**Citizens Coordinating Committee on Friendship Heights**  
**February 28, 2019 Meeting With Regency Centers**  
**Regarding Westwood Redevelopment Plans**

**Total Westwood I Project & Development Phasing**

**Realignment – River Road along the top left of the illustration, curved multi-lane road is Westbard Ave.**

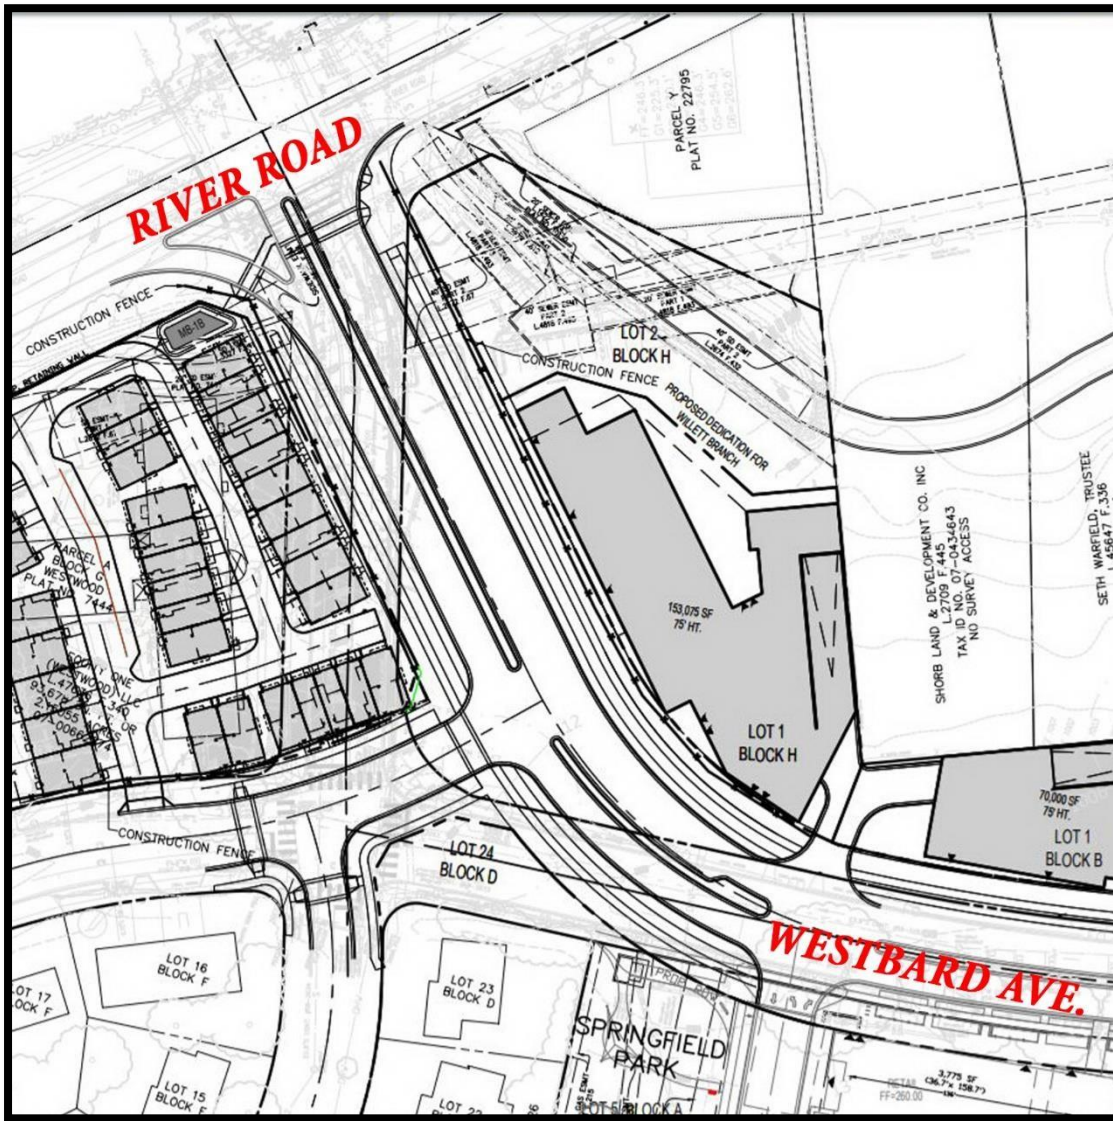
The current Regency plan shows that during construction of Phase 1A (the Giant grocery site) and 1B, (the first group of townhouses) an interim solution will be used to address the problem of Westbard Ave., Ridgefield Rd., and River Rd. This is insufficient to cope with the commuter traffic (Mass. Ave-River Rd) coupled with the increased construction and residential traffic that will be forthcoming. The final realignment is also essential for removal of construction traffic from the residential area of Westbard Ave. extended. In order to avoid entirely foreseeable residential and driver misery the planned Westbard Ave. road realignment must be completed after Phase 1A when the new Giant store is completed and after Phase 1B when the first group of townhouses is built. This must be done before the plans for Phase 1C, the multifamily/retail building, can be finally approved.

Question regarding the number of lanes – does the plan show two heading in from River Rd.? And three heading onto River Rd.?

## Springfield Park

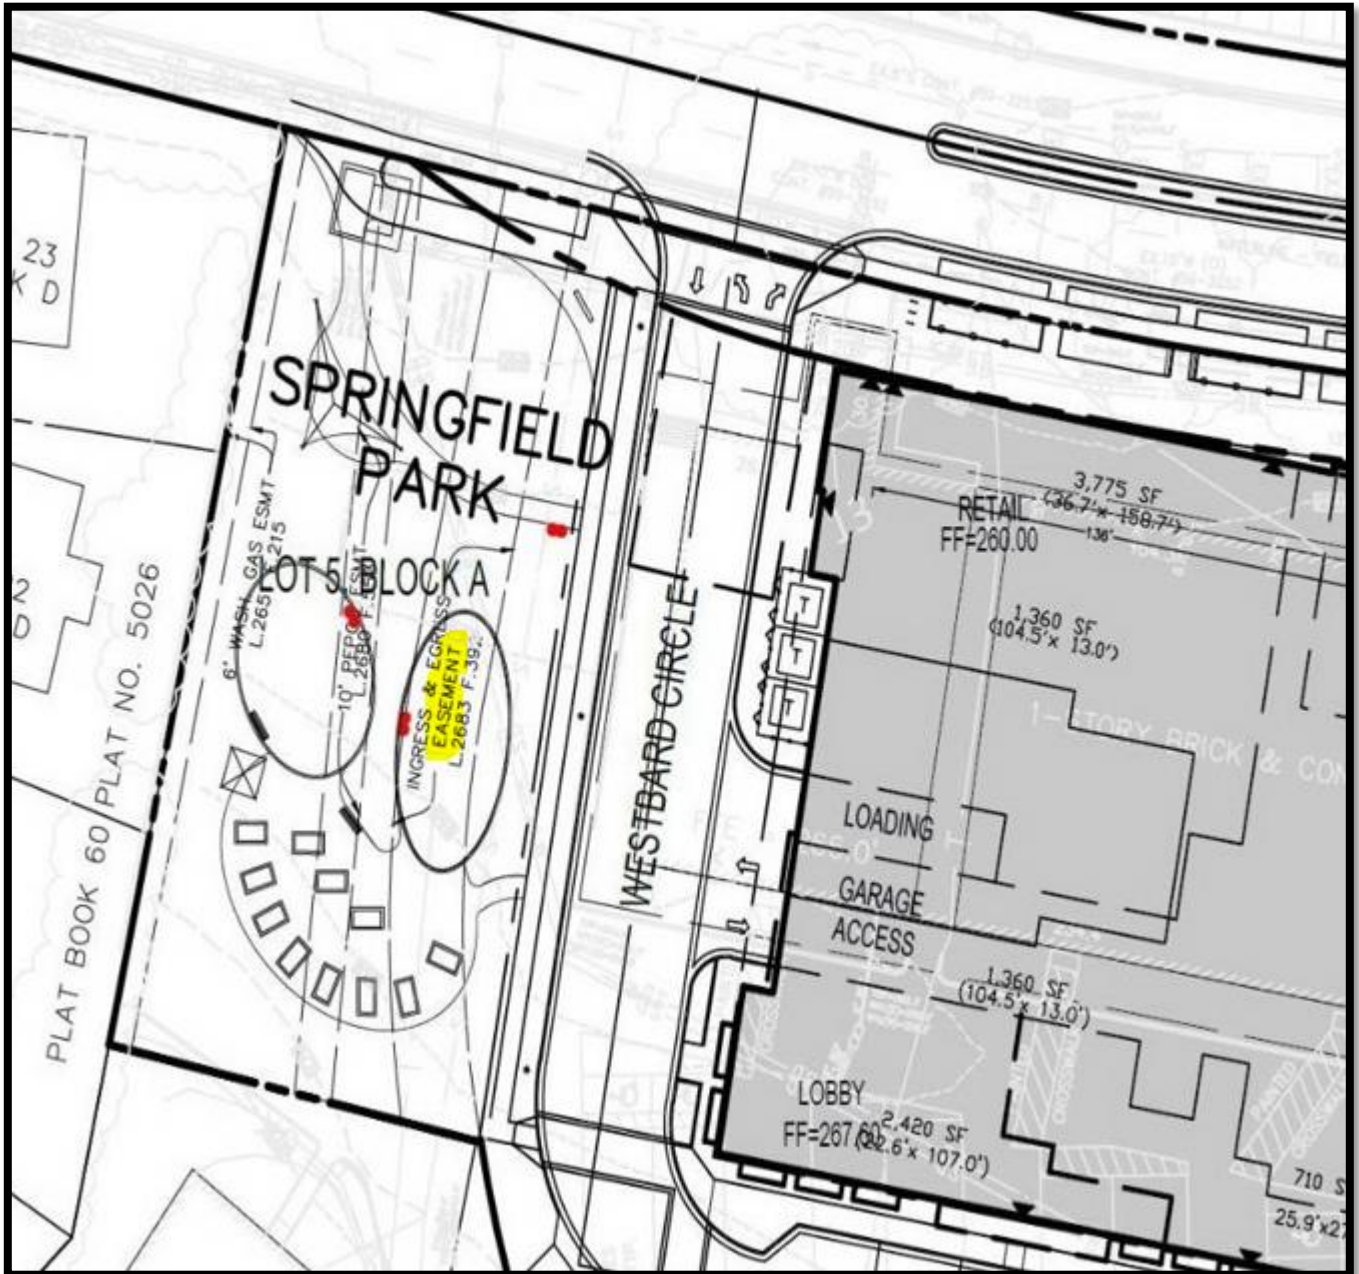
Springfield Park site is expected to be dedicated to the Montgomery County Parks Department. There is a severe shortage of parkland in the immediate vicinity. In order to assure that Springfield Park does not have a roadway running through it, Phase 1B and Phase 1C preliminary and site plans may at most be conditionally approved subject to the condition that the easements at the proposed Springfield Park are resolved by either (1) elimination of the ingress/egress easement to Kenwood Place Condominium (KPC) under the proposed Springfield Park through agreement with KPC or (2) by redesigning Westwood I to include a Springfield Park of the same size at another location. Unless and until that condition is met, the plans would not be finally approved and therefore would not constitute a required basis for building permits

**Civic Green**

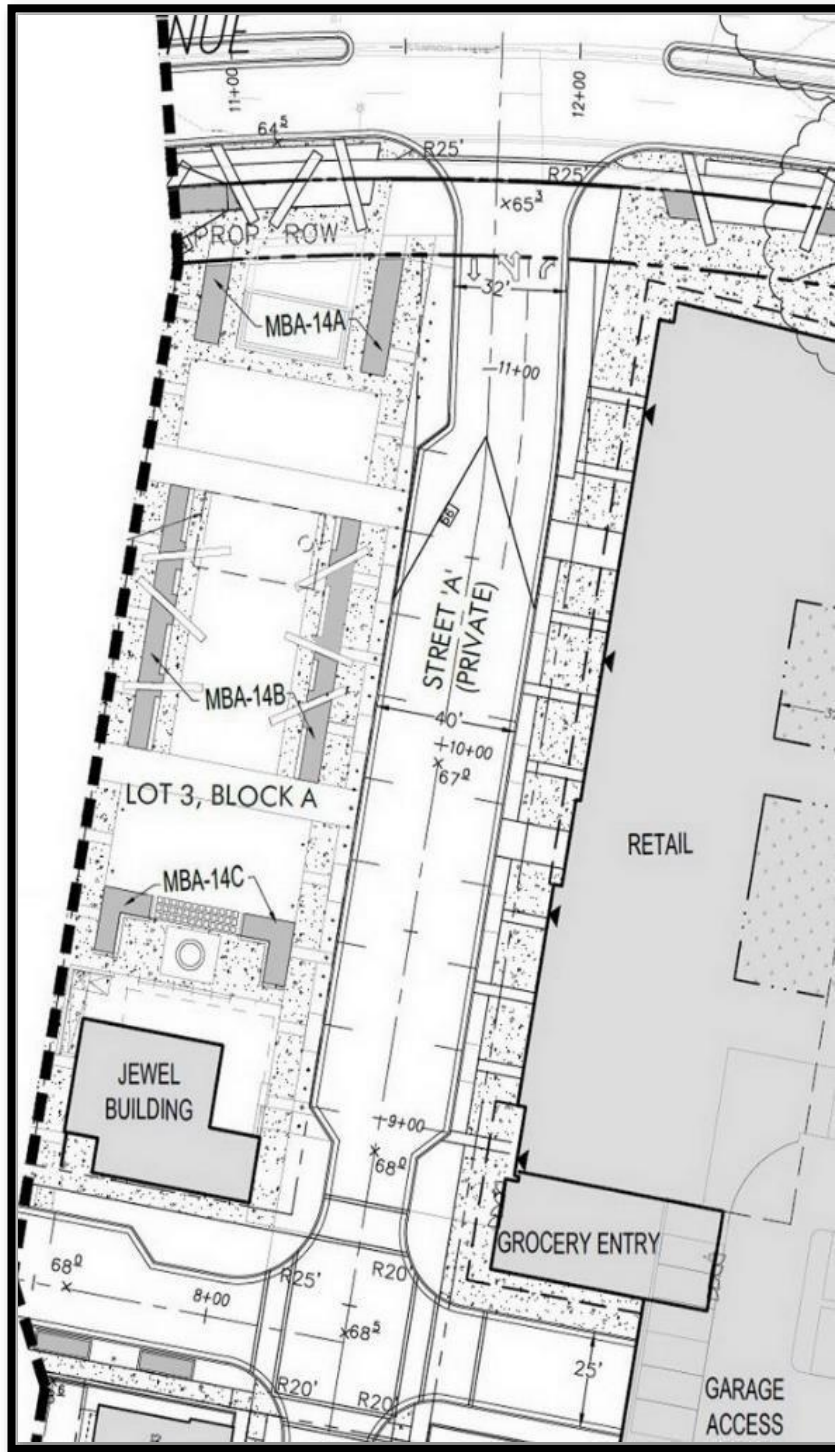
Much of the Civic Green is hardscape with benches, sidewalk and perhaps other accessory structures. We object to the plans until details are provided on the design, the area of greenspace and dimensions of the space.

**Willett Branch and Greenway**

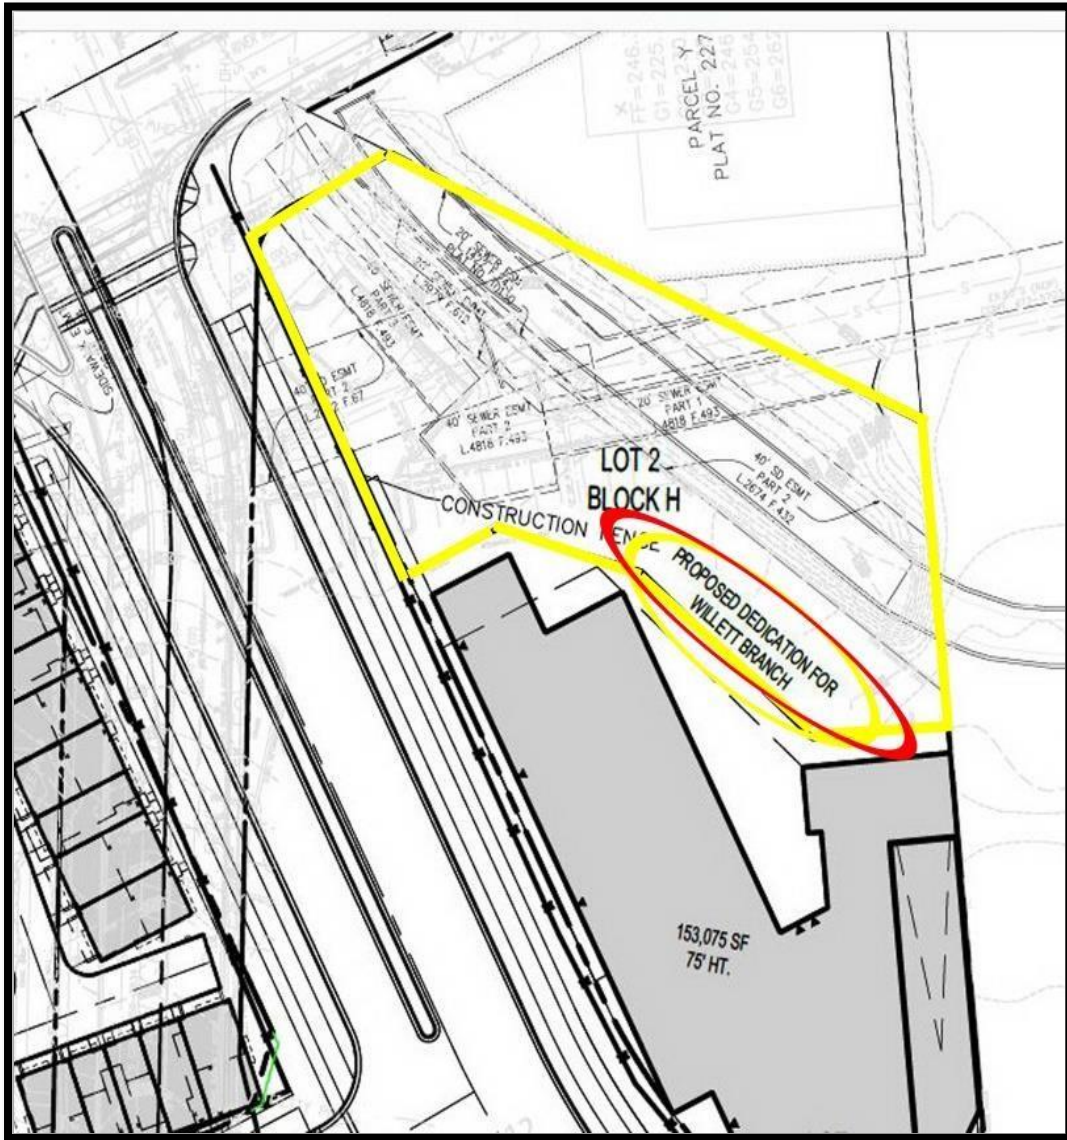
Dedication of land for Willett Branch in the vicinity of Ridgefield Road and River Road must occur with Westbard realignment prior to Phase 1C, and Regency's Phase 1C site plan should not be deemed finally approved until the realignment is complete.

In order for there to be the necessary flexibility to accommodate a trail of the Willett Branch Greenway on the western side of the Willett Branch, which may be necessary particularly if the eastern side does not become available, as well as for park maintenance, Regency needs to convey a property interest that is 20 feet wide, starting from the top edge of the steep downward slope behind Bowlmor. That should be dedicated to Parks. In addition, there needs to be public access from Westbard Avenue, which would be in an existing easement and an extension of that easement on the northern side of the Bowlmor property along the HOC boundary.
